## Technical Service Bulletin

**MODEL(S) AFFECTED:** **Tennant T2** (North America Models)  
Models manufactured before serial number 10539697 (September 2011)

**SUBJECT:** Onboard Battery Charger

Fig. 1

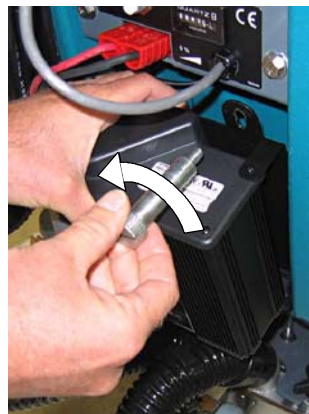
1. Remove charger from machine (Figure 1).
2. Remove the round plug from bottom of charger to access profile switches (Figure 2).
3. Set profile switches according to chart. Charger MUST be unplugged when resetting.

Battery Type	Switch	1	2
Wet / lead acid		ON	OFF
LM Wet / low maintenance		ON	ON
Gel / Sealed		OFF	ON
Exide Gel		OFF	OFF
